RECEIPT DATE: 9-25-17 **ONSITE SEWAGE DISPOSAL SYSTEM**

OSDS Plan
2039 Terrapin Creek Road
Terrapin Creek, Lot 15
Woodstock, MD 21163

The OSDS Plan for Terrapin Creek, Lot 15 has been reviewed with the following comments:

ON SITE SEWAGE DISPOSAL SYSTEM DESIGN PLAN

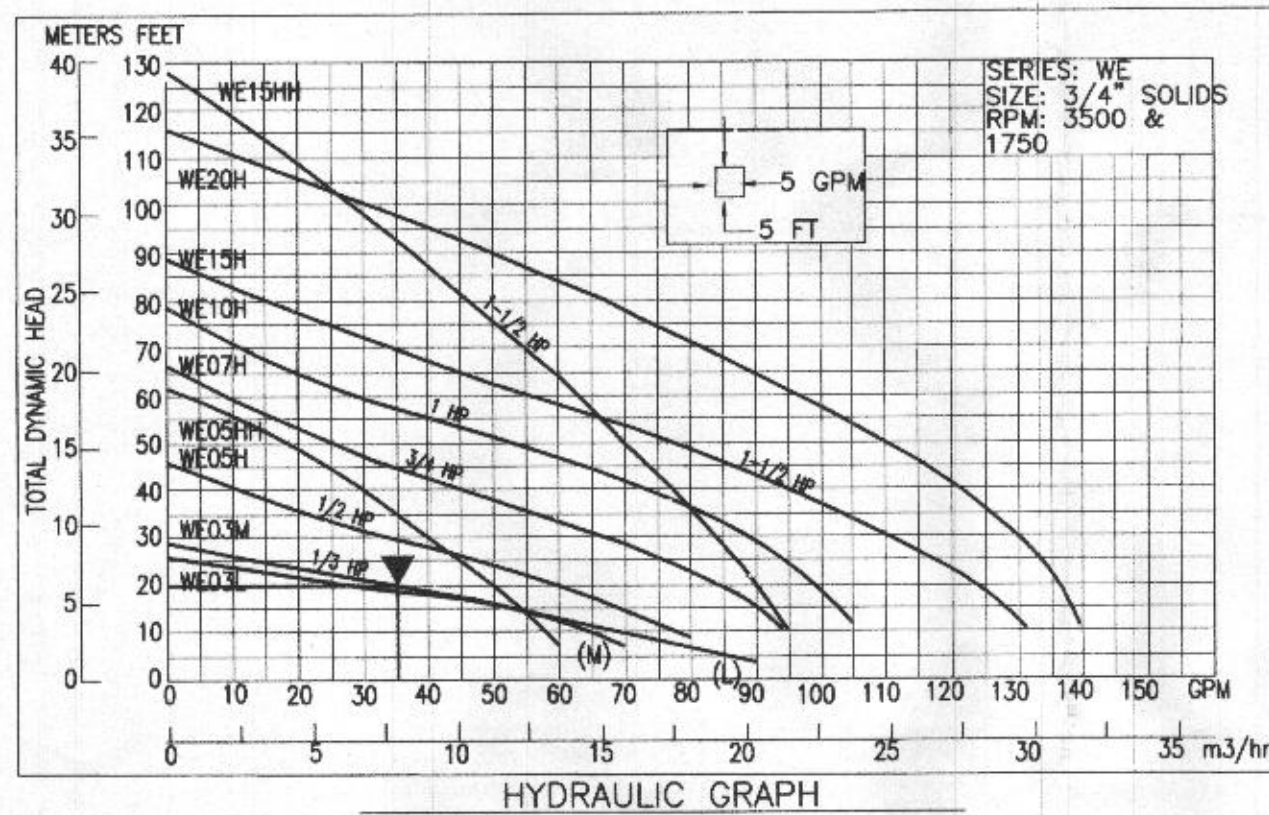
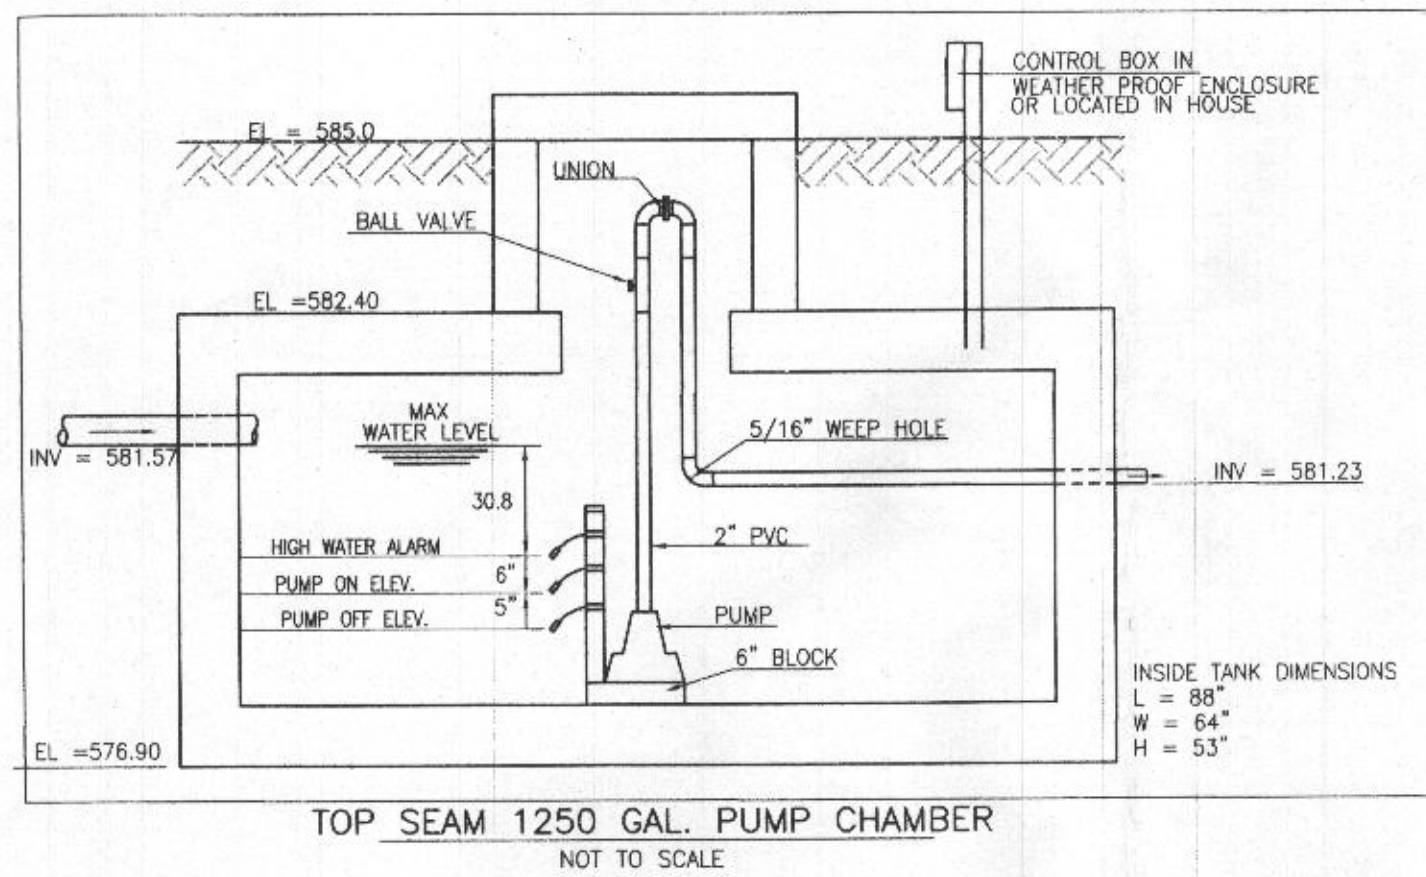
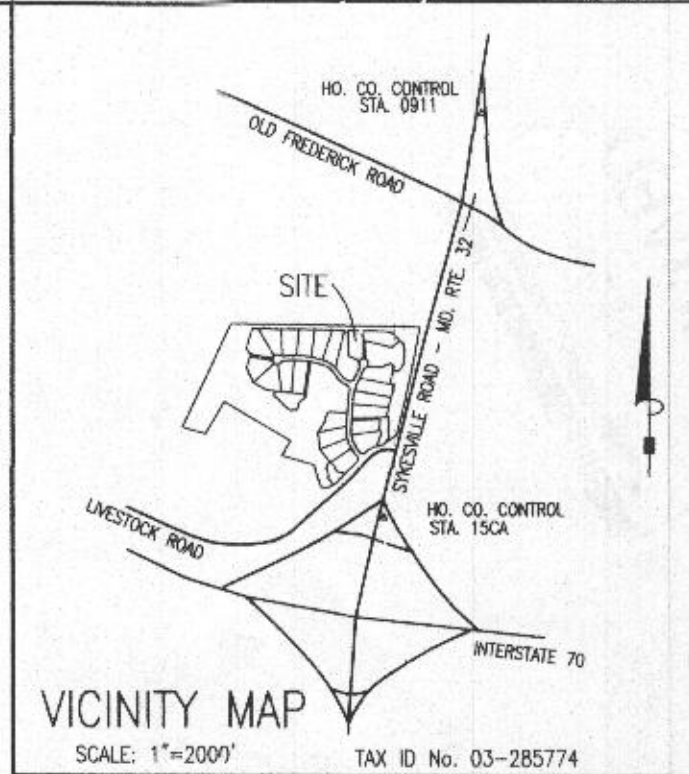
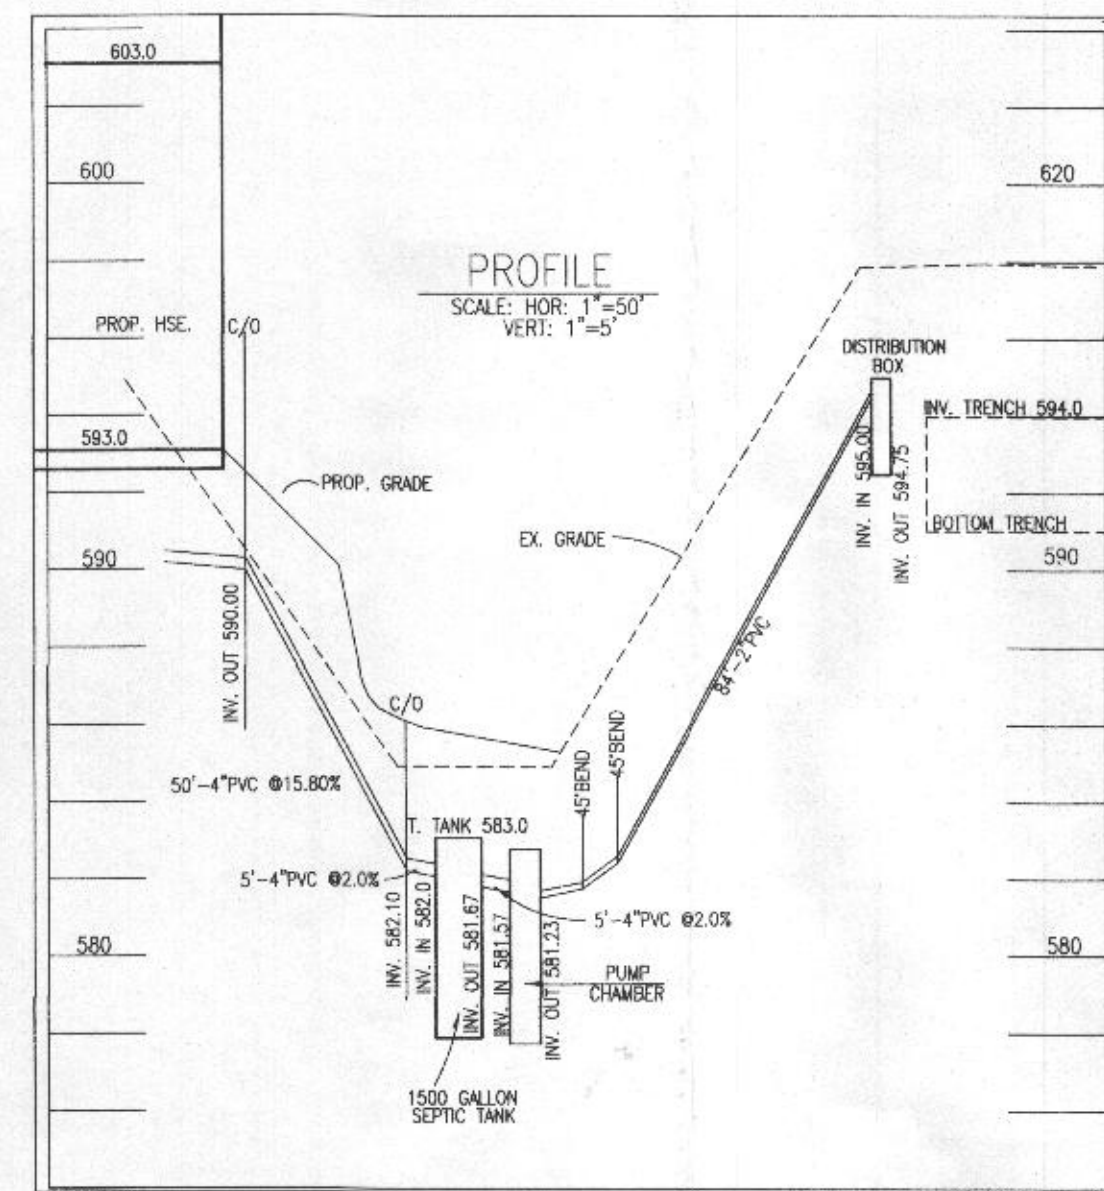
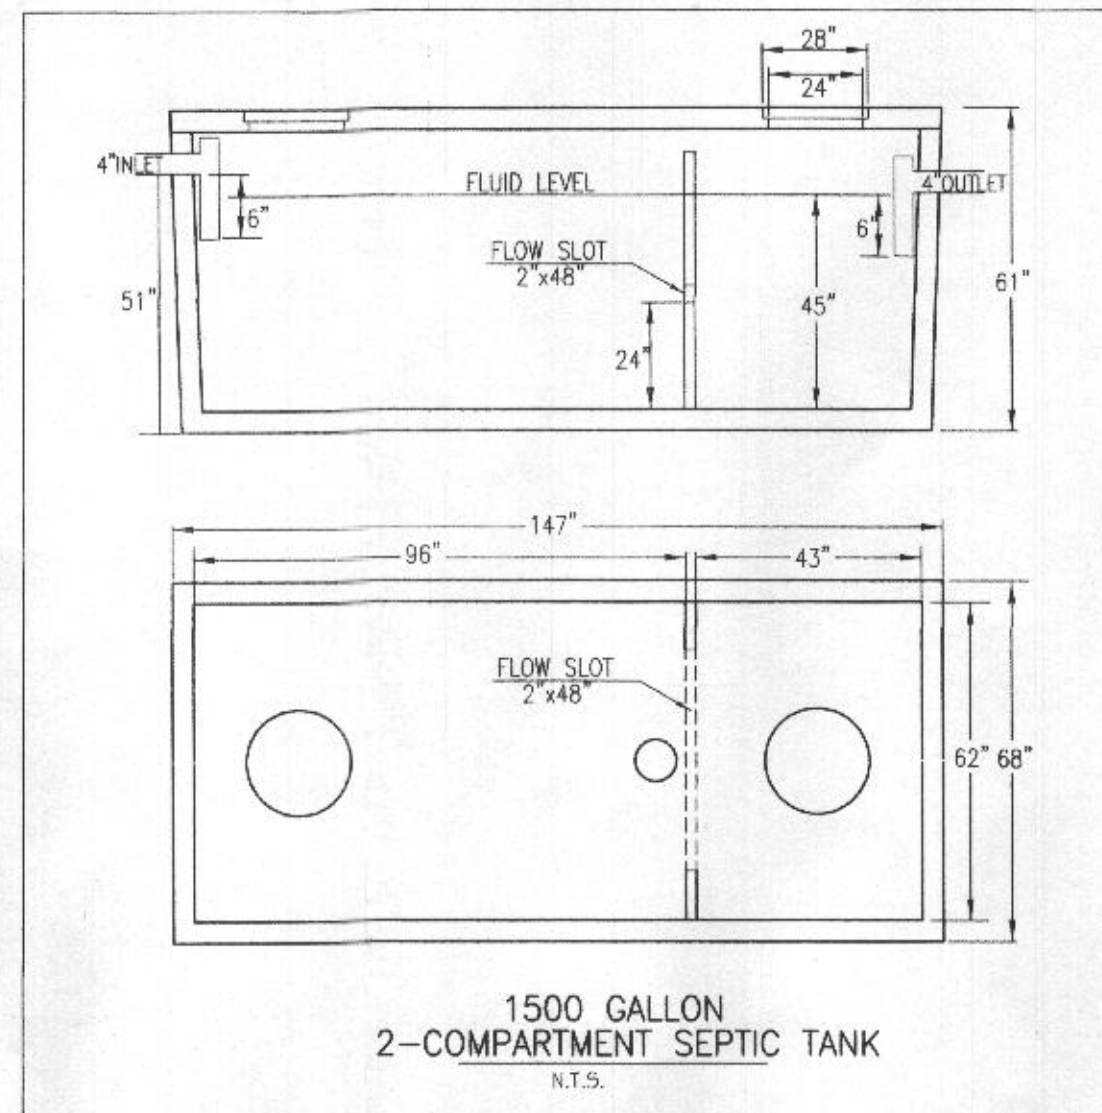
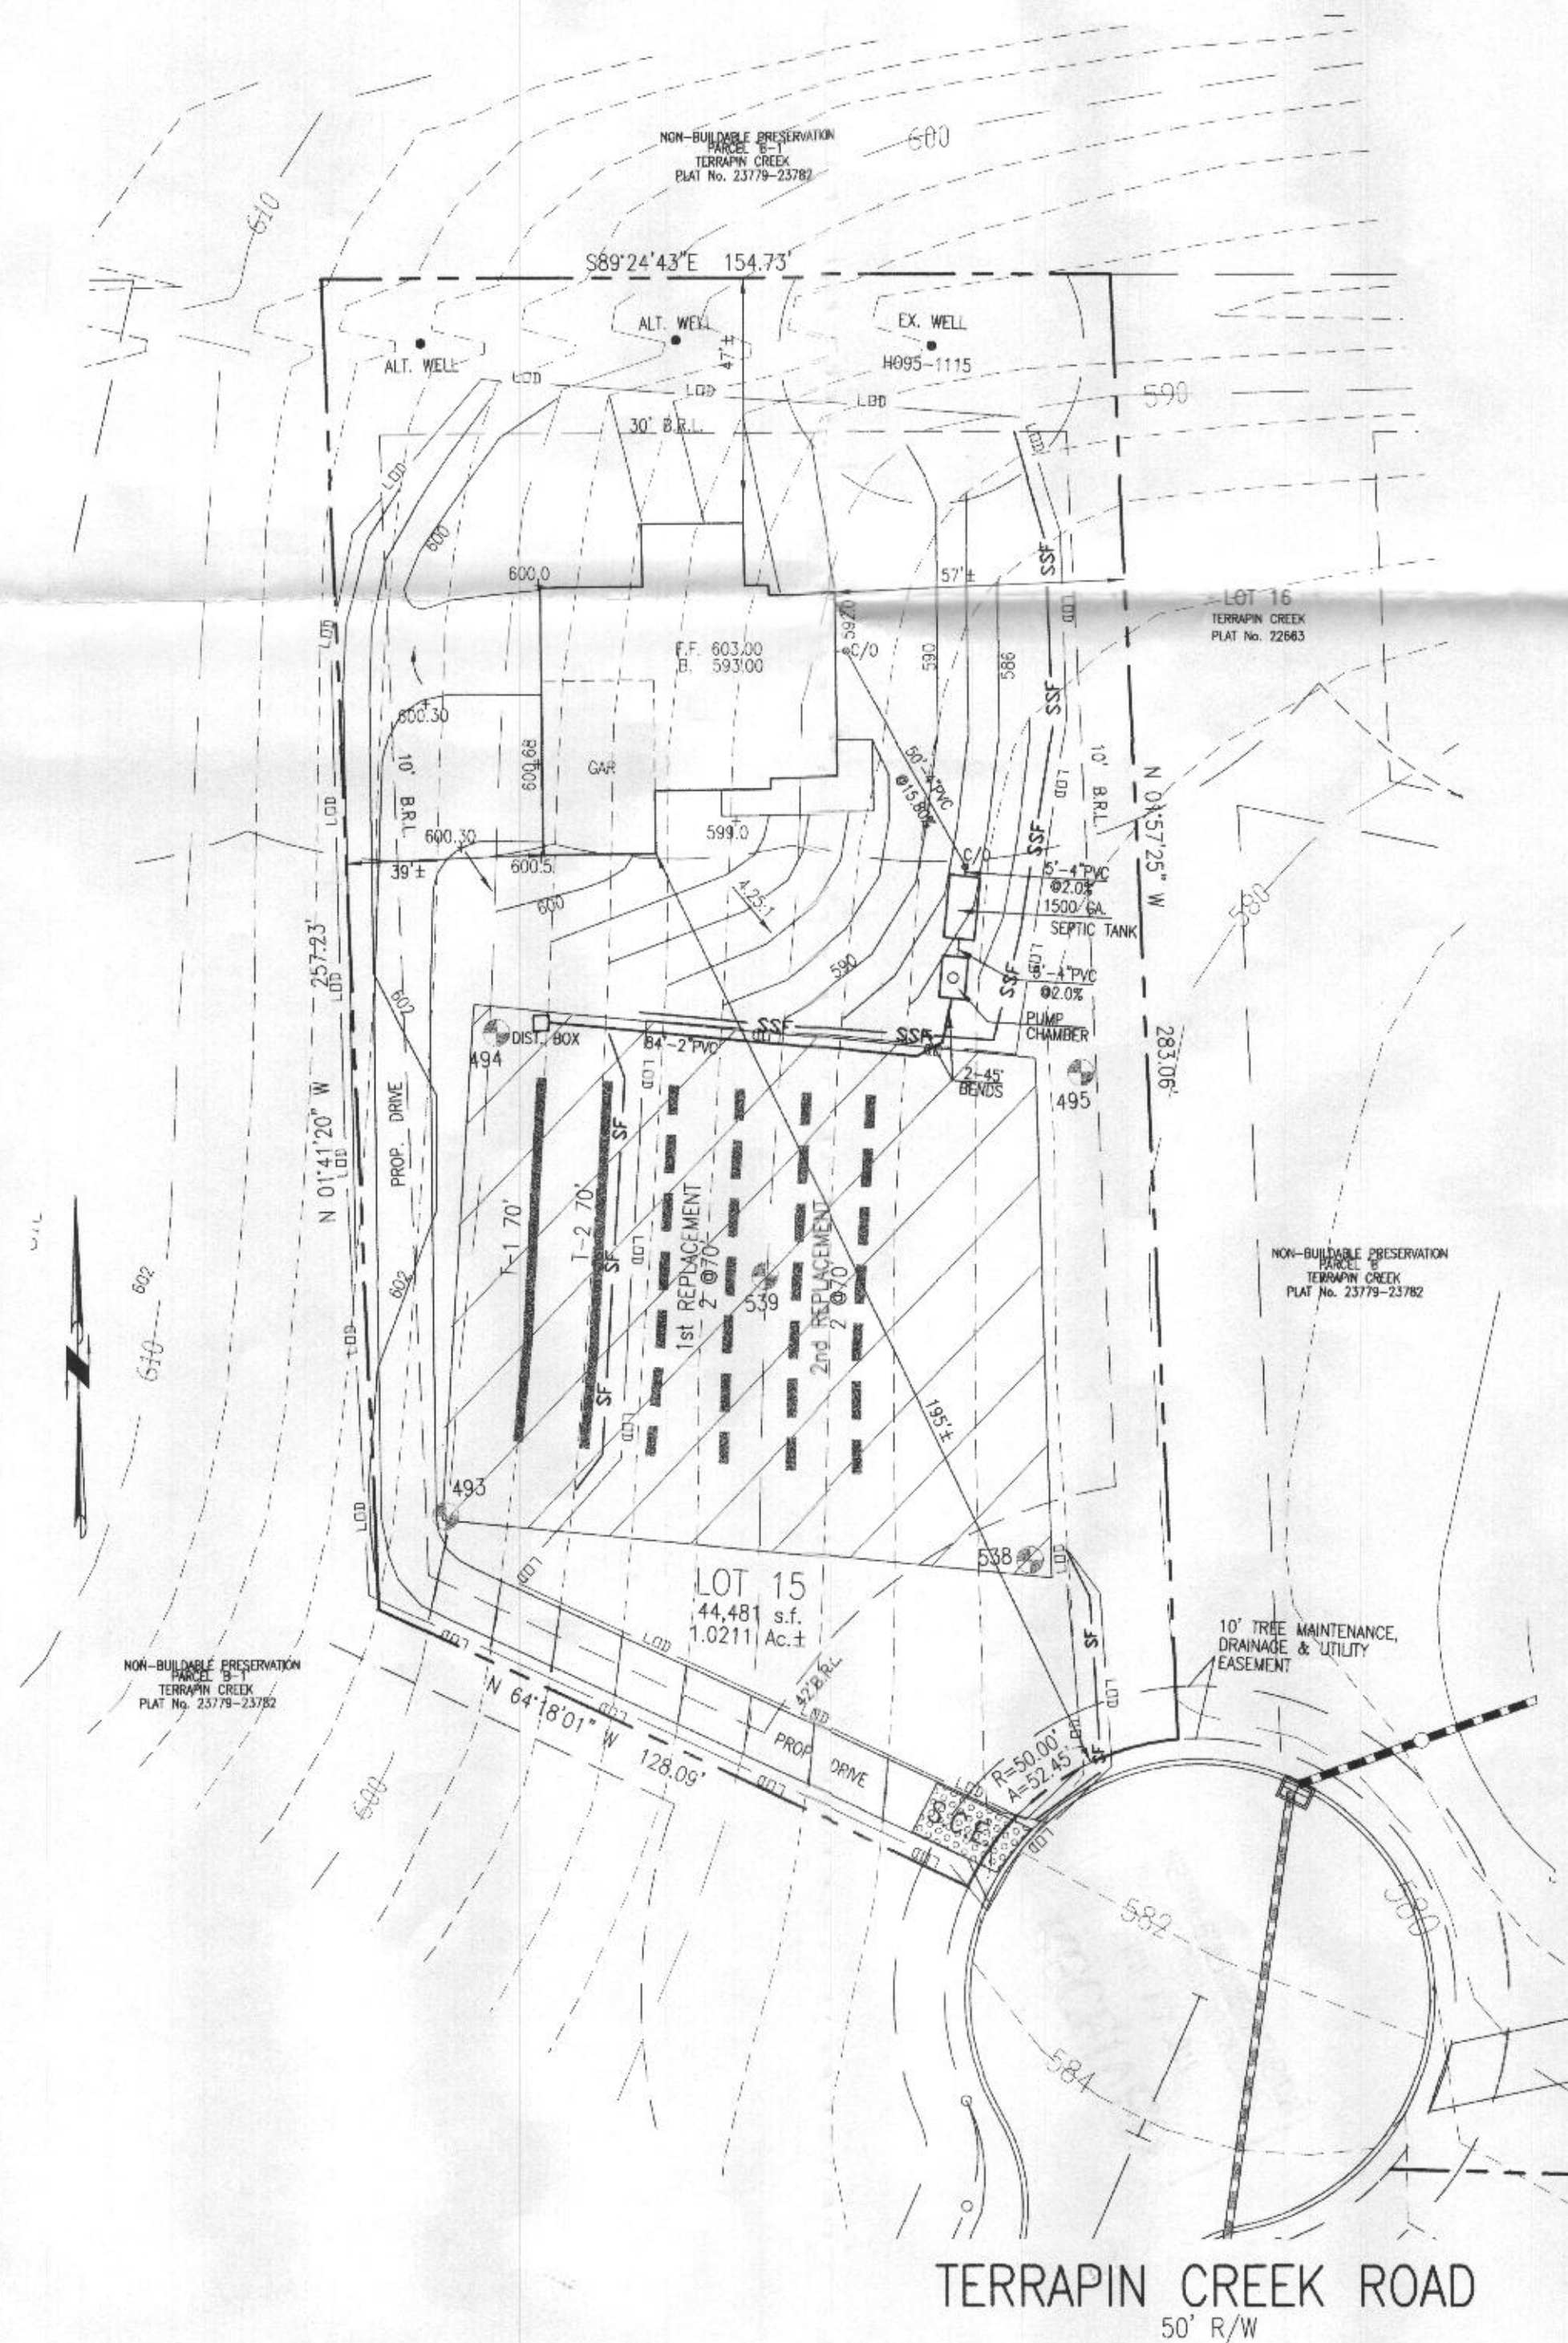
- 1.) The friction loss should be more like ^{2.75 using 1.5 GPM} 2.05 (per sand mound chart)
- 2.) The TDH would be more like ~~19.69~~ (use 20) ^{20.09} use .
- 3.) TDH of 20 intersects the pump curve at 35 GPM
- 4.) Pump should be a 1/3 HP, WE03.
- 5.) Pump runtime = 3 minutes.
- ✓ 6.) Change wording in calculation to 2nd replacement
- ✓ 7.) House detail elevations do not match Layout elevations on plan
- ✓ 8.) Move d-box inside SDA
